**Re: City of Fort Collins East Rigden Pit Substitute Water Supply Plan
(WDID 0302570, Plan ID 3055)
DRMS File No. M-1979-097 (WDID 0303021)
Sections 21, 27 & 28, T7N, R68W, 6th P.M.
Water Division 1, Water District 3, Larimer County**

Approval Period: July 1, 2020 through June 30, 2021
Contact information for Mr. Shuler: 303-806-8952; jshuler@bbawater.com

We have reviewed your letter dated April 22, 2020 requesting approval of a substitute water supply plan ("SWSP") on behalf of the City of Fort Collins ("Applicant" or "Fort Collins") in accordance with section 37-90-137(11), C.R.S., to cover depletions caused by an existing gravel pit operation known as the East Rigden Pit (M-1979-097). The required renewal fee of \$257 has been received (receipt no. 10003233).

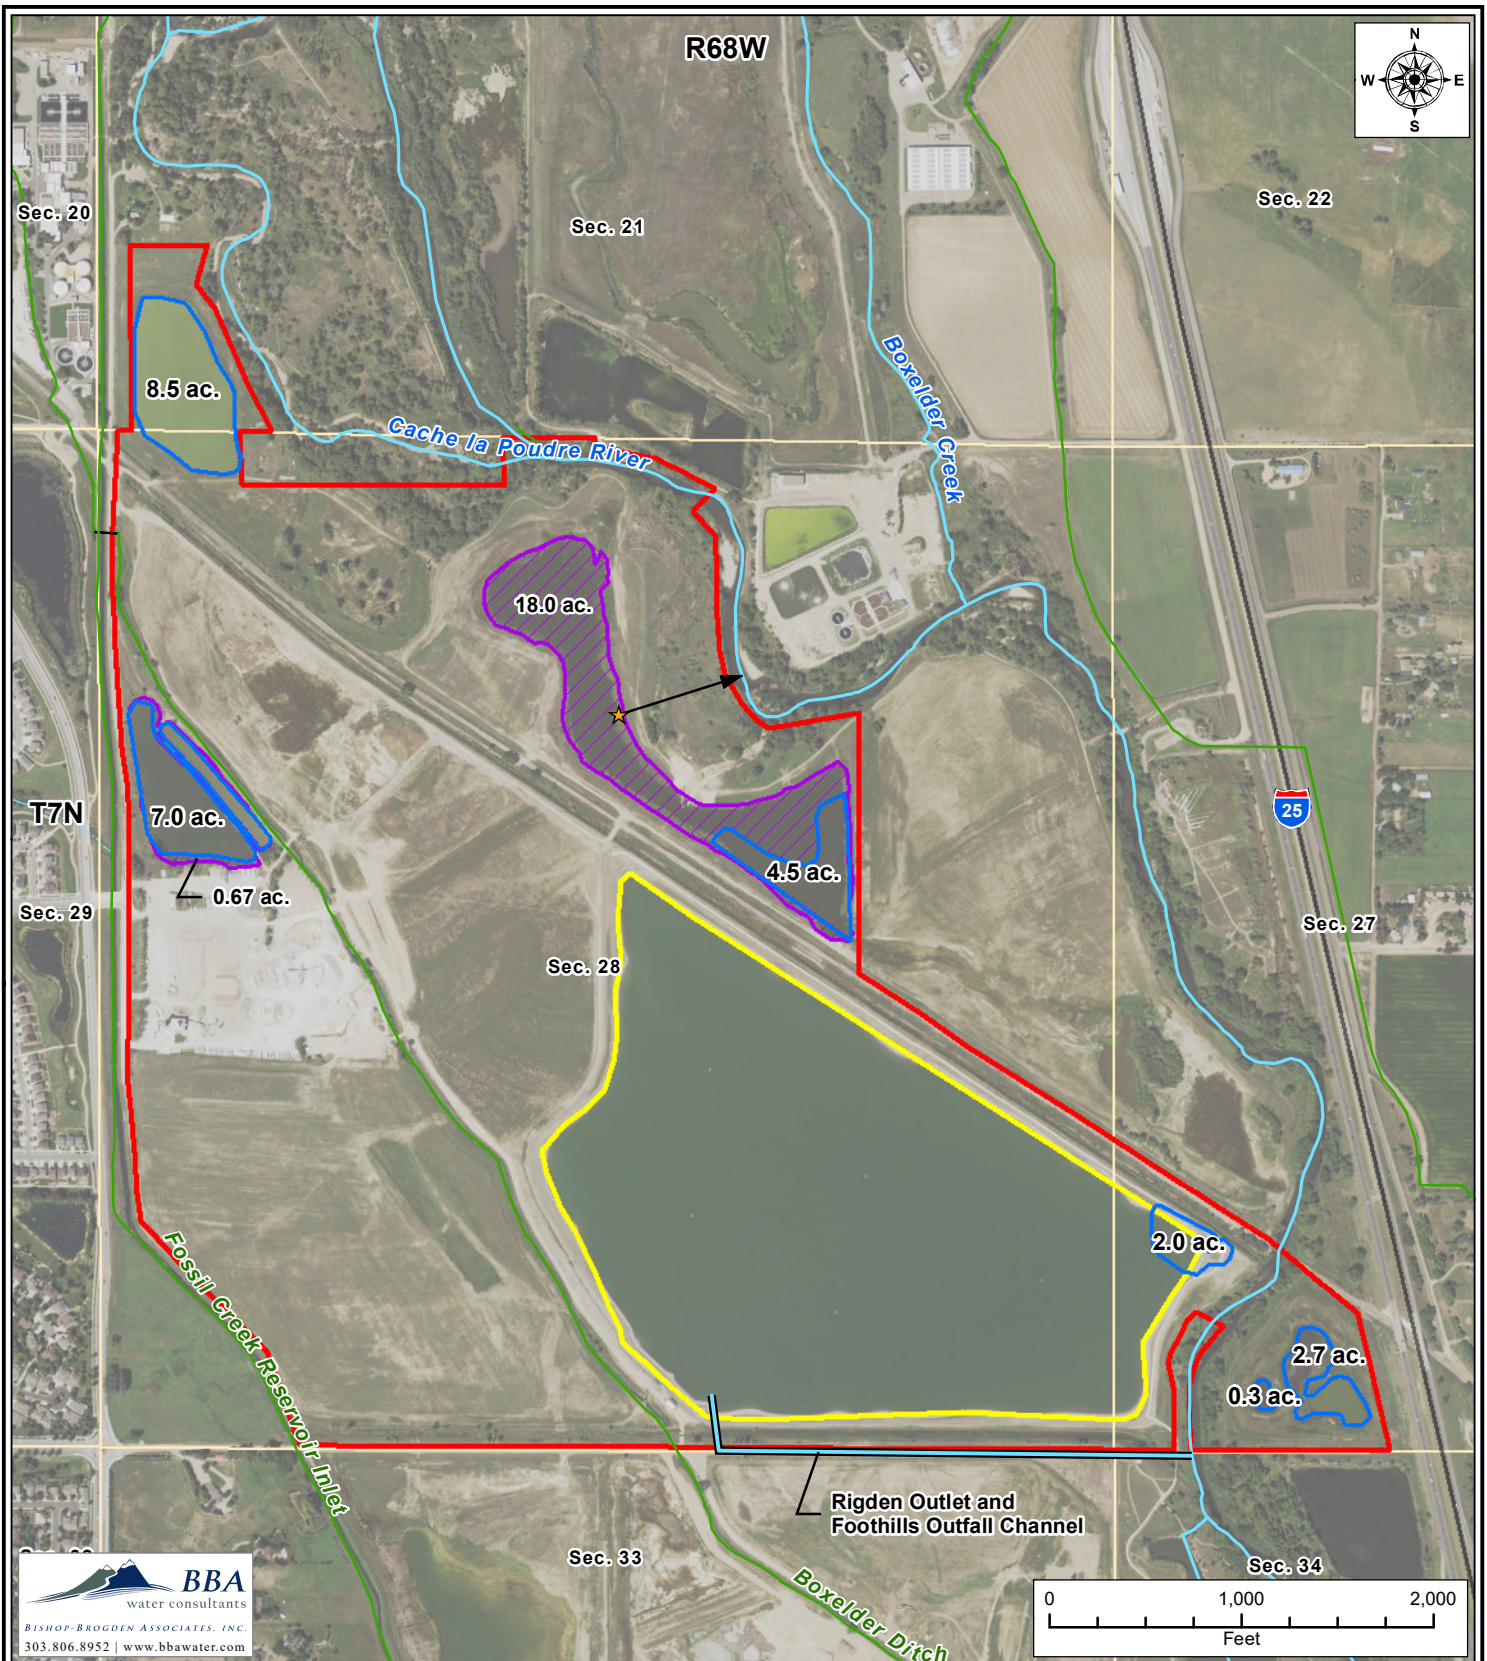
The East Rigden Pit is located along the Cache la Poudre River in Sections 21, 27, and 28, Township 7 North, Range 68 West of the 6th P.M. as shown on the attached Figure 1. Sand and gravel mining exposed groundwater at the pit site but according to a January 2019 inspection report from the Division of Reclamation, Mining and Safety ("DRMS") the area has not been mined in many years. The 2015-2016 SWSP determined that all 25 acres of groundwater exposed at that time were documented as having been exposed at the site prior to January 1, 1981. Pursuant to section 37-90-137(11)(b), C.R.S. and 2009CW49, a gravel pit operator or property owner does not need to replace depletions that occur due to evaporation from groundwater exposed prior to January 1, 1981 ("pre-81") as a result of open mining of sand and gravel, regardless of whether mining continued after December 31, 1980 ("post-80"). The pre-81 pond extents approved in the 2015-2016 East Rigden SWSP are shown in Figure 1, and may not be re-allocated to other areas of groundwater exposure within the gravel pit boundary. The 2015-2016 SWSP stated that with the SEO approval of the compacted clay liner in the Fort Collins Parcel, no depletions associated with the East Rigden Pit would remain after the conclusion of that plan period and no subsequent SWSP would be required for the site. However, a DRMS field inspection in January 2019 found that the acreage of the exposed groundwater had increased beyond the pre-81 extent. This additional exposed surface area has been included in a substitute water supply plan since July 1, 2019. Fort Collins does not plan to conduct any mining activities during the term of this SWSP, therefore the
